**Proposal for modification of
ECE/TRANS/WP.29/GRE/2020/16 (draft amendment to the
Consolidated Resolution on the common specification of light
source categories)**

The text reproduced below was prepared by TF S/R, on the basis of document ECE/TRANS/WP.29/GRE/2020/16, with the purpose to improve the approval codes for electrical/electronic controls not integrated with the replacement light source in an additional electronics device.

*After sheet H11/LED/7, insert new sheets H11_LED/1 to 7, to read:
(see the following pages; one page per sheet)*

Figure 1: Main drawings

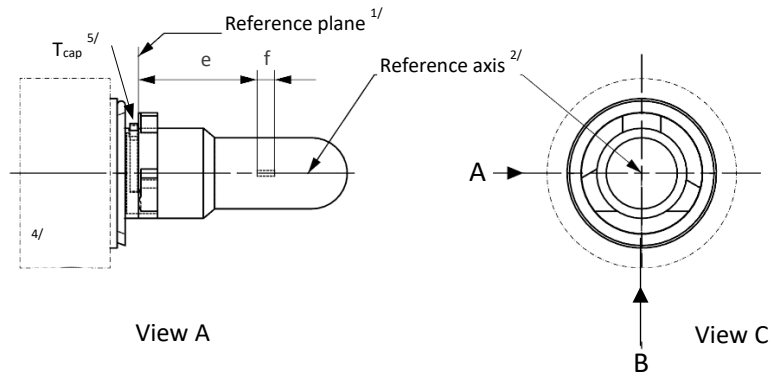
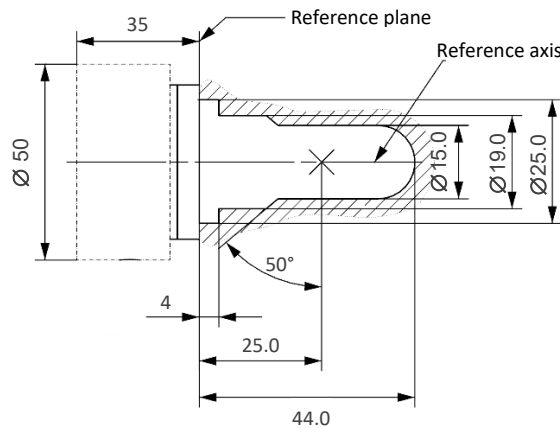
- ^{1/} The reference plane is the plane formed by the underside of the bevelled lead-in flange of the cap.
- ^{2/} The reference axis is perpendicular to the reference plane and passing through the centre of the 19 mm cap diameter.
- ^{3/} The LED light source shall not exceed the envelope as indicated in Figure 2.
- ^{4/} The light source shall function in either voltage polarity.
- ^{5/} Measurement point for cap temperature T_{cap}
